List of question to the FD1 Cold Electronics System Team (v. 29-Oct-2022)

Questions related to grounding and shielding

Fig 1(a)

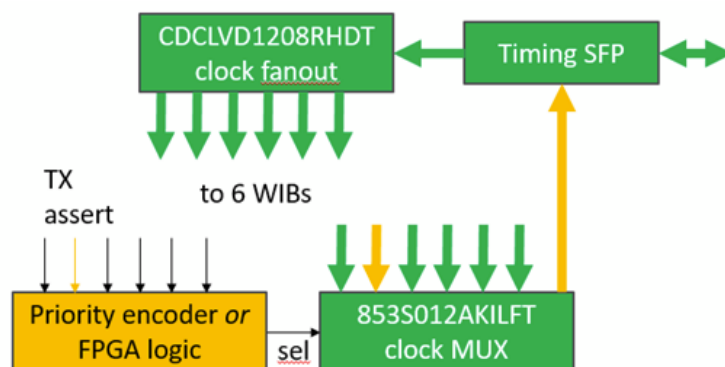
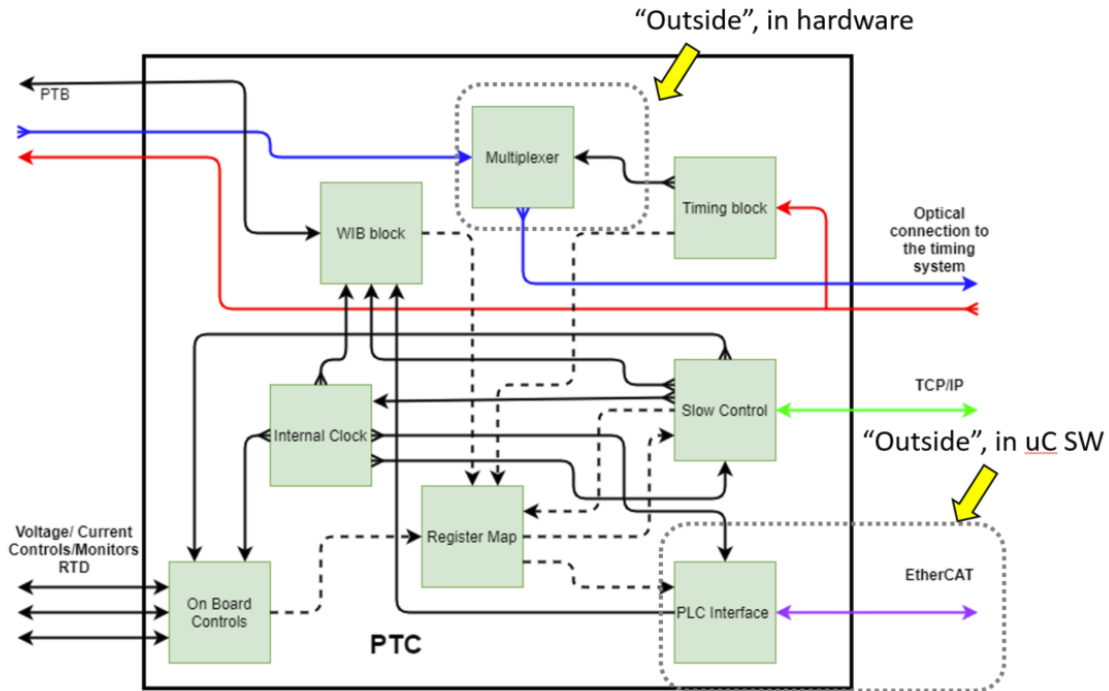
9. "The PTC shall multiplex the return signals from the WIBs and transmit them back to the timing system." Is "de-multiplex" meant here? Are many signals transferred over a single communication line to the timing system here?

The WIB MUXs timing signals coming back from WIB. Each WIB has a point-to-point link back to PTC for transmitting to the timing master, as in Fig 1(a) below.

Fig 1(b) shows an updated firmware diagram, illustrating that this functionality is in hardware, not FPGA.

Fig. 2

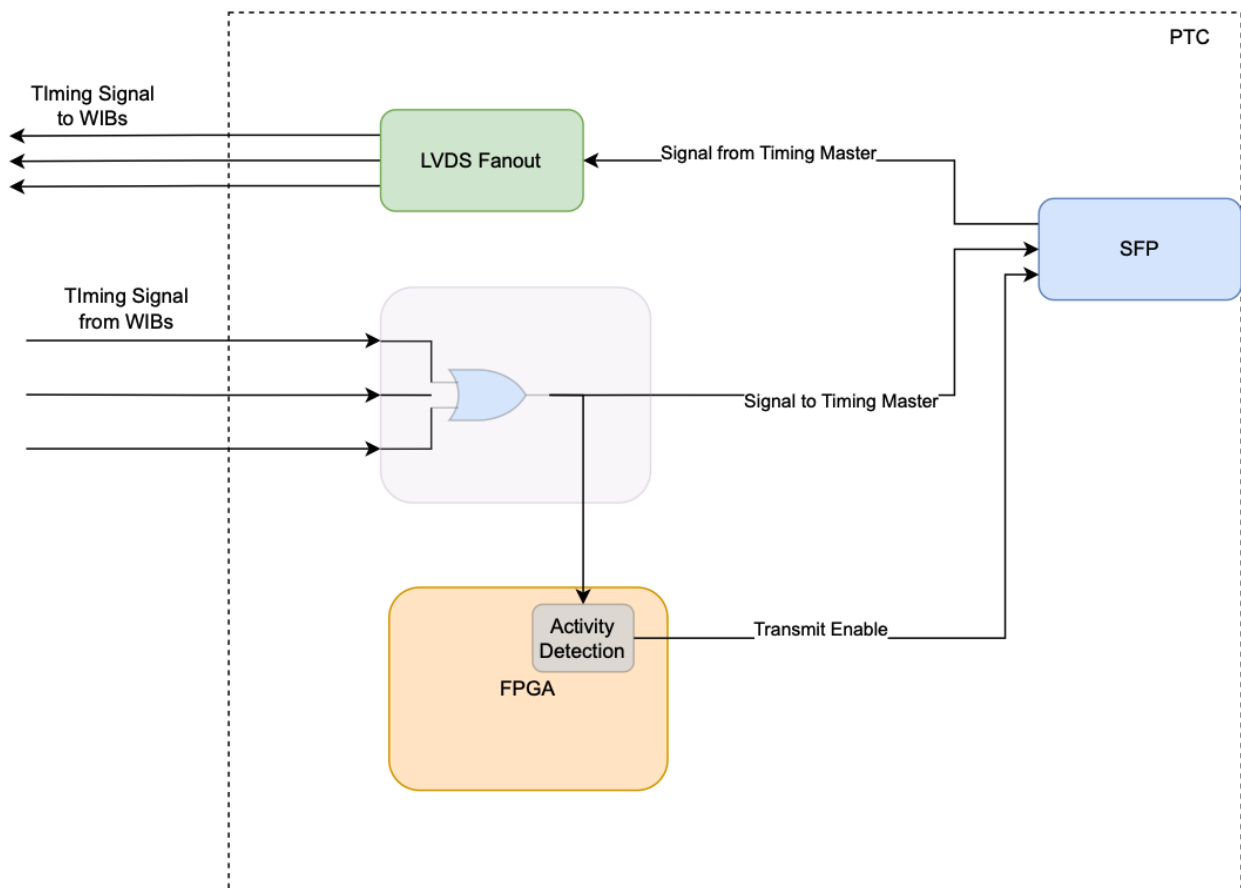
The technical details of the timing system are correctly described, but the proposed solution is complicated to implement and has a risk of not working correctly. Below is a sketch of a possible implementation of the Timing – PTC – WIB link that is much simpler than the one proposed in EDMS 2731292 and much more likely to work:

The explanation of how messages are sent to/from the timing endpoints from/to the timing master is correct. However, the suggested implementation of the fanout/multiplexing of timing signals on the PTC to the WIBs isn't optimal.

1. The suggested implementation (figure 2) routes timing data through the PTC FPGA. This is not optimal.

- a. Accurate measurement of the round-trip delay needs the delay from/to the WIBs to/from the timing master to be symmetrical and stable. If routed through the FPGA this means the data should not be registered (fed through flip flops) inside the FPGA. Asynchronous logic is not easy to implement reliably in standard FPGAs. The delays inside the FPGA may be significant and hence may vary significantly with FPGA temperature. Also, the delays may vary every time the firmware is rebuilt unless complex placement constraints are implemented.

- b. The standard timing endpoint firmware only recognizes one endpoint address. Modifying the endpoint firmware to recognize multiple addresses (for the multiple WIBs in the crate) will require effort. The timing group is happy to assist with all areas of integration, but is not enthusiastic about writing custom firmware for the PTC.

- c. There is a much simpler implantation (illustrated in above sketch):
 - i. Fan-out the timing data from the timing master in an external LVDS fanout chip

- ii. Use a logical "OR" to combine the data from the multiple WIBs. This works because the timing data output from a WIB that doesn't have the Tx enabled is "0". Feed a copy of the "ORed" data to the FPGA

into logic that detects 0/1 and 1/0 transitions. If there are transitions, the FPGA asserts the "Tx enable" line to the PTC SFP. When there are no further transitions, after a timeout, the FPGA de-asserts the Tx-enable line. The DCSK protocol guarantees one 0/1 transition and one 1/0 transition every 16ns so the timeout can be very short compared to the SFP laser turn on/off time (up to 1ms)

The diagram in the draft requirements is out of date. See diagrams in PTC Question #9 for details – I believe this is consistent with the explanation in this section.
